UNITED STATES PATENT AND TRADEMARK OFFICE

APPLICATION NO.	FILING DATE	FIRST NAMED INVENTOR	ATTORNEY DOCKET NO.	CONFIRMATION NO.
10/662,453	09/16/2003	Mitsuhiro Sugimoto	4633-0107P	2514
2292	7590	07/27/2006	EXAMINER	
BIRCH STEWART KOLASCH & BIRCH PO BOX 747 FALLS CHURCH, VA 22040-0747			CALEY, MICHAEL H	
			ART UNIT	PAPER NUMBER
			2871

Office Action Summary	Application No.	Applicant(s)
	10/662,453	SUGIMOTO ET AL.
	Examiner	Art Unit
	Michael H. Caley	2871

DETAILED ACTION

FIG.14

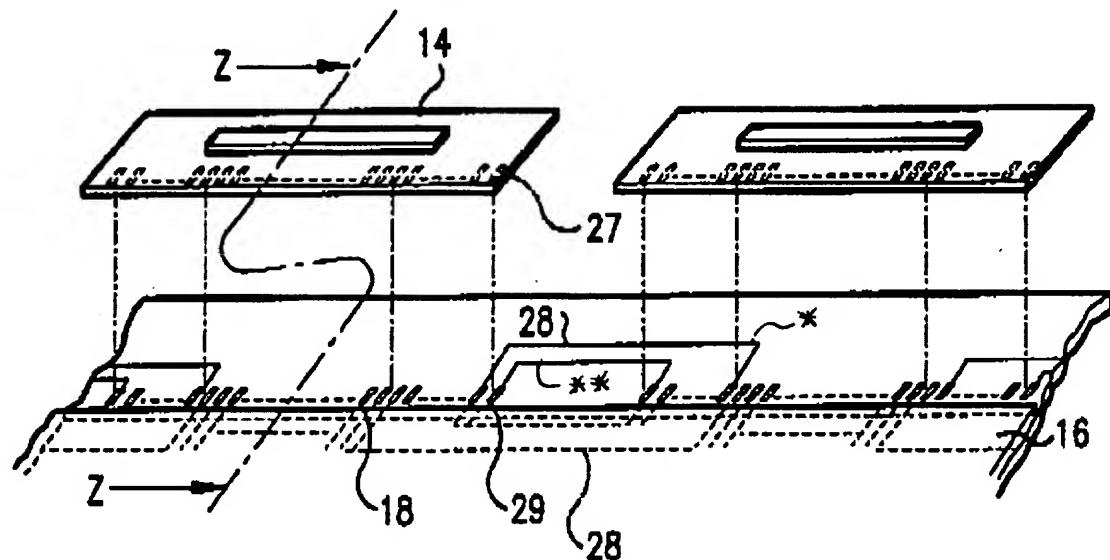
a display panel having panel side connection wiring (Figure 14 element 28);
a first wiring board having an insulation base (Figure 14 element 14, left board), a driving circuit element (Figure 11 element 4) for driving the display panel, a first wiring path (Figure 11 element 8) connected to the driving circuit (Figure 11), a second wiring path (Figures 11 part of elements 5 and 27 connected to element 29 and outer line 28) and a third wiring path (Figure 11 separate part of elements 5 and 27 connected to element 29); and

a second wiring board identical to the first wiring board (Figure 14, right side board);

wherein the panel side-connection wiring connects the second wiring path of the first wiring board to the first wiring path of the second wiring board (Figure 14 element 28, line marked with “*” below).

Regarding claim 15, Uchiyama discloses the panel-side wiring as connecting the third wiring path of the first board to the second wiring path of the second board (Figure 14 element 28, line marked with “**” above).

Regarding claim 16, Uchiyama discloses the panel-side connection wiring as not connecting any of the first, second, and third wiring paths of the second board to the first wiring path of the first board (Figure 14).
